3.2 115-133 Cotham Road, Kew - VCAT Outcome for Mixed Use Development - PA23/0031

STATUTORY PLANNING DELEGATE REPORT

Office and Residential Hotel Development at 115-133 Cotham Road, Kew

Application Number	PA23/0031 (VCAT Reference: P723/2023)
Date Application Received	20 October 2022
Planning Officer	Daniel Murphy
Applicant	Cotham Service Pty Ltd C/- Urbis
Property Address	115-133 Cotham Road, Kew
Existing Permit Preamble	Development and the use of the land for the purposes of office and residential hotel, the sale and consumption of liquor (pursuant to clause 52.27), and a reduction in the standard car parking requirement and of the loading requirements in accordance with endorsed plans.
Existing Permit Number	PP06/01357
Proposal	Amendment to the Permit
Zoning	Commercial 1 Zone
Overlays	Design & Development Overlay - Schedule 16 Parking Overlay - Schedule 1
Area of Cultural Heritage sensitivity?	No
Aboriginal Cultural Heritage	No
Covenant	None indicated on title
Number of Objections Received	Eleven (11) statements of grounds have been received by Council, including eight (8) objectors who have elected to participate as a party to the VCAT proceedings.

VCAT Discussion Lobby/Cafe Plan 12 September

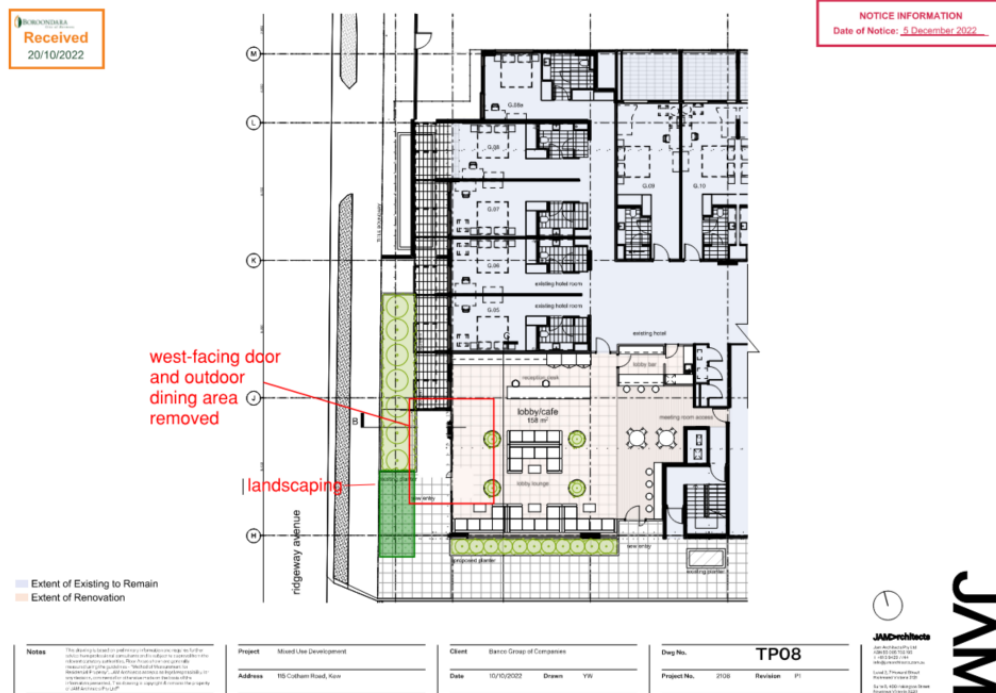
- The residential hotel entrance will be relocated to the internal porte cochere, which is accessible via the existing double crossover to Ridgeway Avenue.
- The existing landscaping buffer along the western boundary of the subject site,

adjacent to the residential hotel entrance, will be reinstated.

- The west-facing doors and outdoor seating area adjacent to the residential hotel lobby will be deleted.
- The internal layout of the residential hotel lobby, including a lobby lounge, reception desk and seating area will remain as previously proposed.
- It remains the case that four (4) residential hotel rooms at ground floor level will be deleted to facilitate new residential hotel entry, as previously proposed.

Marked-up plan detailing the agreed layout changes to the residential hotel entrance.

- (a) The entry and terrace to the residential hotel lobby facing Ridgeway Avenue deleted and the landscaping area to be retained generally in accordance with the Sketch Plan VCAT 12 September 2023.

VCAT Discussion Restaurant Plan 12 September

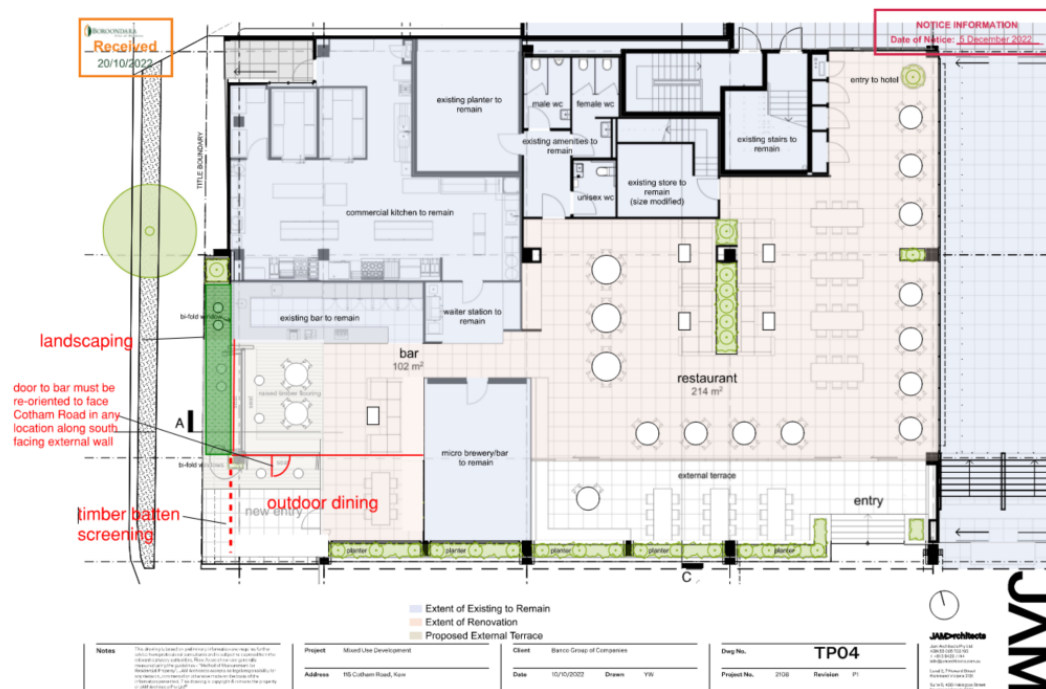
- The western restaurant and bar entrance will be reconfigured. This includes relocating the entry to the premises from a new door in the southern elevation, which is orientated towards Cotham Road.
- A timber batten screen, adjacent to restaurant and bar entrance will be introduced to prevent patrons from exiting the premises directly onto Ridgeway Avenue.
- The outdoor seating area adjacent to the corner of Cotham Road and Ridgeway Avenue will be reorientated towards Cotham Road, rather than Ridgeway Avenue as previously proposed.
- The bi-folding windows to Ridgeway Avenue will be deleted.
- The existing landscaping along the western boundary of the subject site, adjacent to the restaurant and bar entrance, will be reinstated.

Marked-up plan detailing the agreed layout changes to the restaurant and bar entrance.

The in-principle agreement also amends the layout of the restaurant and bar entrance, adjacent to the corner of Cotham Road and Ridgeway Avenue. These modifications to the entrance will include the removal of openable bi-fold windows, reorientate the entrance to the southern elevation and provide timber batten panels adjacent to the entry, which run parallel with the western boundary of the site. The effect of these layout changes will be a redesigned restaurant and bar entrance which funnels patrons onto Cotham Road when exiting the venue, rather than more sensitive areas on Ridgeway Avenue, as previously proposed.

- (b) An updated Materials Schedule (TP12) to show the clear glazing as GL8 and to show the colour and finish of any new glazing.
- (c) The outdoor bar area reorientated to face Cotham Road generally in accordance with the Sketch Plan VCAT 12 September 2023.

- (d) The outdoor bar area interfacing with Ridgeway Avenue to be screened with a full height treatment that prevents pedestrian access directly to Ridgeway Avenue generally in accordance with the Sketch Plan VCAT 12 September 2023.
